From: Clare Benson <cbenson@nlpplanning.com>
Sent: 05 March 2013 15:35
To: Hannah Barker
Cc: Andrew Rowe; Claire Heathcote; Daniel Lampard; Paul Archer
Subject: Royal Coach - Shoreham by Sea [NLP-DMS.FID207085]
Attachments: image002.jpg; 3299-P107d Proposed & Existing Elevations.pdf; image003.jpg; PAINT COLOURS.jpeg; 3299-P106d Proposed First Floor.pdf

ROYAL COACH
SHOREHAM BY SEA

PROPOSED & EXISTING ELEVATIONS

PROPOSED FIRST FLOOR

PROPOSED SOUTH ELEVATION

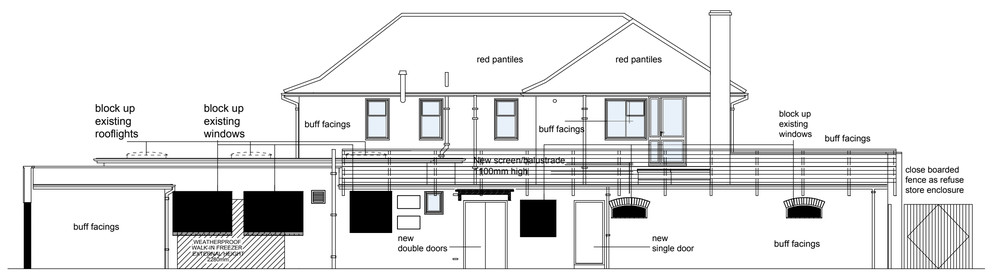
3) elevational drawings showing the appearance of the plant/extract etc in the context of the appearance of the building
Building Control and Marston's Health & Safety Consultants have requested that a protective balustrade is provided around the edge of the flat roof. This balustrade will also be used to screen to the plant/extract equipment. It will be horizontal boarding to be self finished rabetted bevel 6 by Vincent timbers (as above). The screen will sit 1100mm high from the top of the roof. The following attached drawings illustrate the details of the proposed screen/balustrade:

- Proposed First Floor 3299-P106d (supersedes 3299-P106c); and
- Proposed and Existing Elevation s 3299- P107d (supersedes 3299-P107c) - see south elevation for details of the proposed screen/balustrade.

RABETTED BEVEL

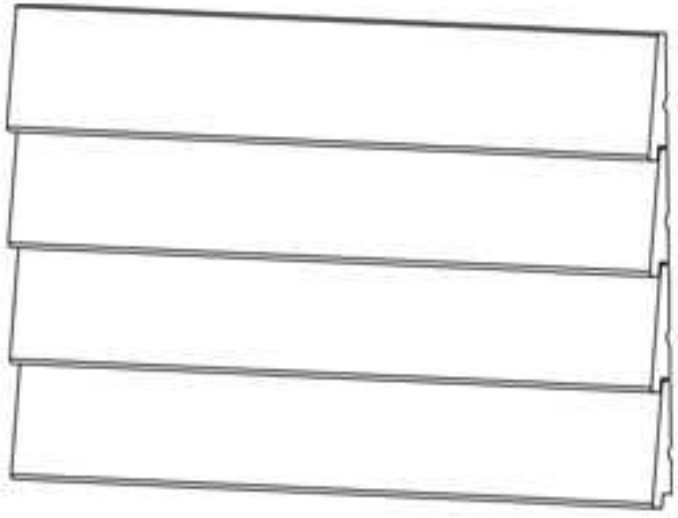
2) details of the timber boarding - material and finish
The new timber horizontal boarding to be self finished rabetted bevel 6 by Vincent timbers (illustrations attached). The timber will be painted Johnstone's Inspired collection colour Blackmoore
